WINGS - ACCESS PANEL INSTALLATION FOR FORWARD SPAR

This service document provides parts and instructions to trim the lower skin and install an access panel on the wings.

MEB-57-02
Page 1 of 8

Figure 1. Access Panel Installation For Forward Spar (Sheet 1)

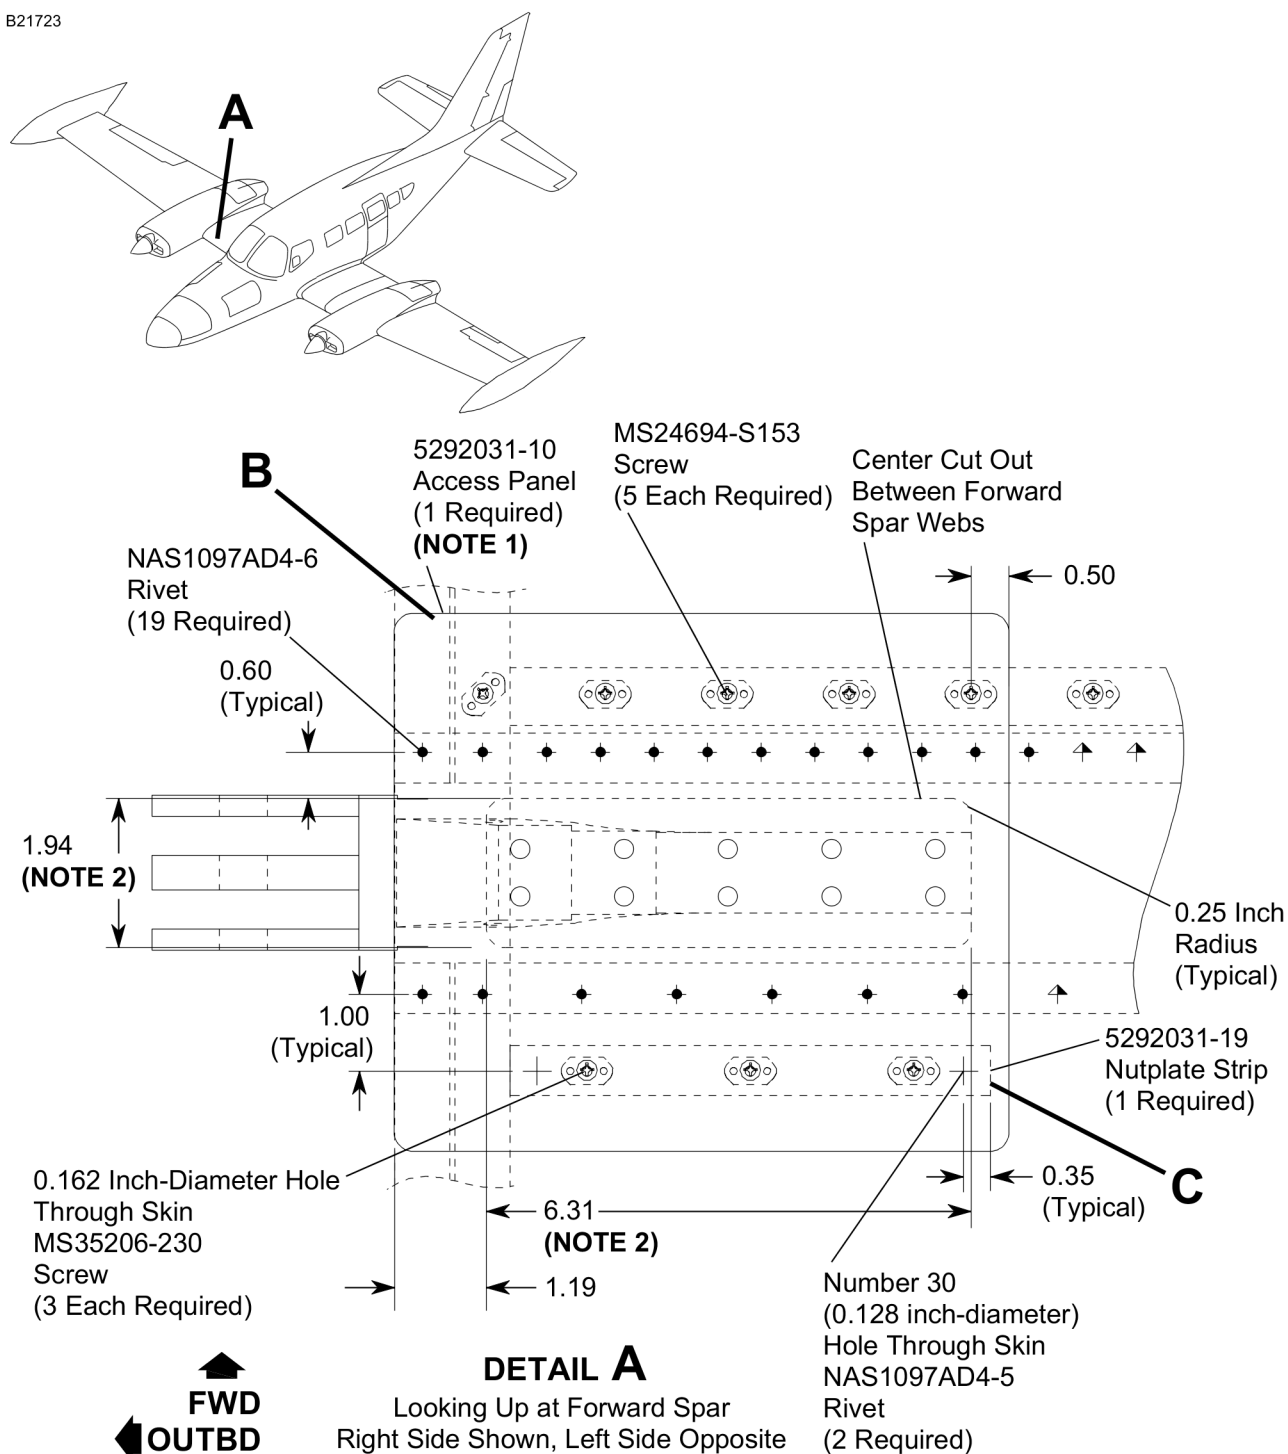
4. (Refer to Figure 1, Detail A.) Make the cutout in the lower right wing skin.

NOTE: The cutout dimension is identified in Figure 1 Detail A.

- A. Identify the area to cut the lower wing skin between the engine and fuselage inboard of the rib.
- B. Put the 5292031-10 (or fabricated) Access Panel into position and trace the outline on the lower wing skin.
- C. Remove the rivets that are inside the traced panel outline.
- D. Countersink the holes where the rivets were removed 100° x 0.190 inch-diameter.
- E. Insert a piece of scrap stainless steel between the lower wing skin and the lower forward spar cap

- F. Make the cutout in the lower wing skin at the identified area.
 - G. Deburr the cutout.
 - H. Remove the scrap stainless steel.
 - I. Protect the edges of the cutout with U074093 Color Chemical Film and K000574 Corrosion Resistant Primer.

5. (Refer to Figure 1, Detail A.) Install the nutplate strip on the right wing.
- A. Put the 5292031-19 (or fabricated) Nutplate Strip into position and identify the hole locations.

6. (Refer to Figure 1, Detail A.) Install 19 NAS1097AD4-6 Rivets to attach the skin to the wing structure on the right wing.
7. (Refer to Figure 1, Detail A.) Install the access panel on the right wing.

Figure 1. Access Panel Installation For Forward Spar (Sheet 2)

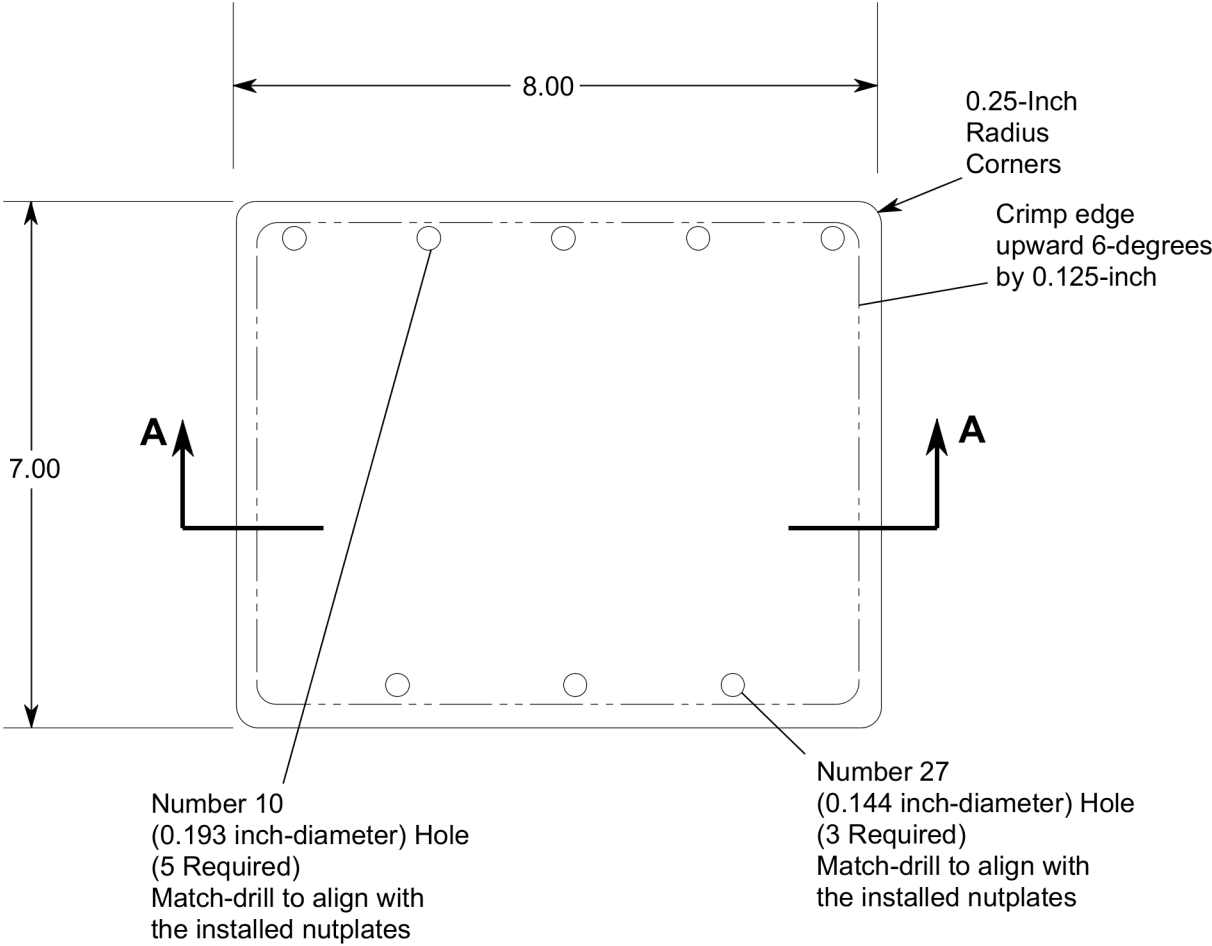
2. (If 592031-10 Panels are not purchased.) (Refer to Figure 1, Detail B.) Fabricate the access panels.
 - A. Cut out two 7.00 inch by 8.00 inch rectangles from the S3806-11 Sheet Material or ALCLAD 2024-T3.

- B. Radius the corners 0.25 inch.
 - C. Identify one surface on each of the panels as UP.
 - D. Roll or crimp the outer 0.25 inch of the panel upward 6° around the perimeter.

DETAIL B

5292031-10 Access Panel
Fabricate from S3806-11
(0.05-Inch Alclad 2024-T3)

Figure 1. Access Panel Installation For Forward Spar (Sheet 3)

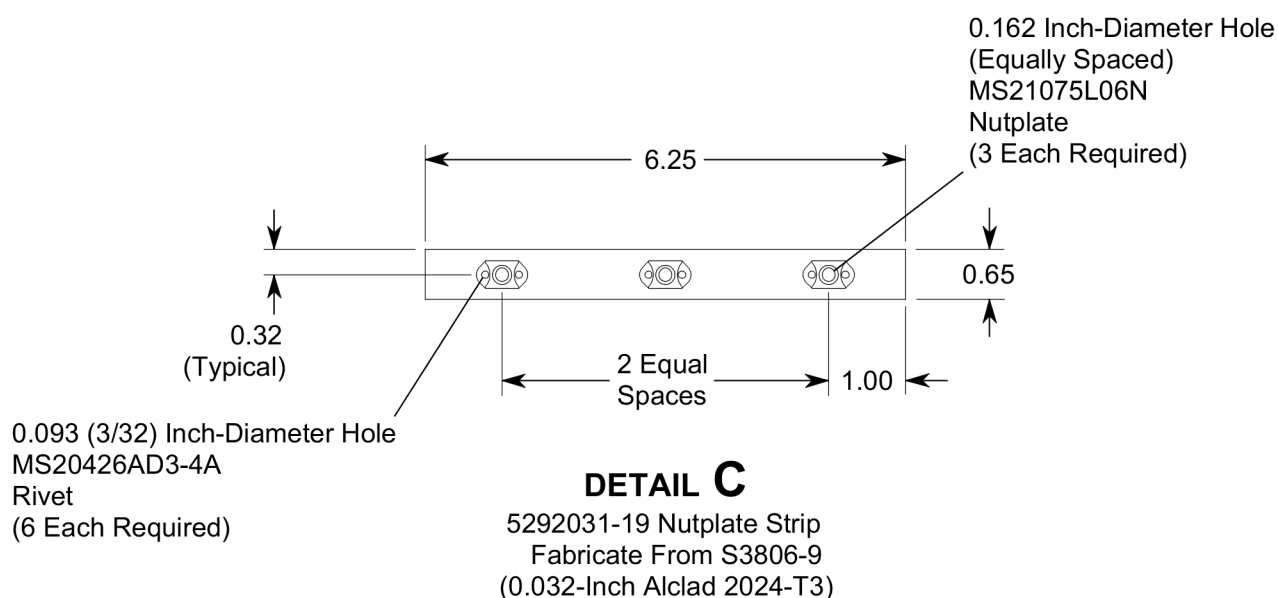
- E. Protect the fabricated panels with U074093 Color Chemical Film and K000574 Corrosion Resistant Primer.
3. (If 5292031-19 Nutplate Strips are not purchased.) (Refer to Figure 1, Detail C.) Fabricate the nutplate strips.

- A. Cut out two 6.25 inch by 0.65 inch rectangles from the S3806-11 Sheet Material.
 - B. Drill three equally spaced 0.162 Inch-Diameter Holes in each strip.

- C. Match drill the six 0.098 Inch-Diameter Holes for the MS20426AD3-4A Rivets in each strip.
- D. Protect the strips with U074093 Color Chemical Film and K000574 Corrosion Resistant Primer.
- E. Install three MS21075L06N Nutplates with six MS20426AD3-4A Rivets in each strip.
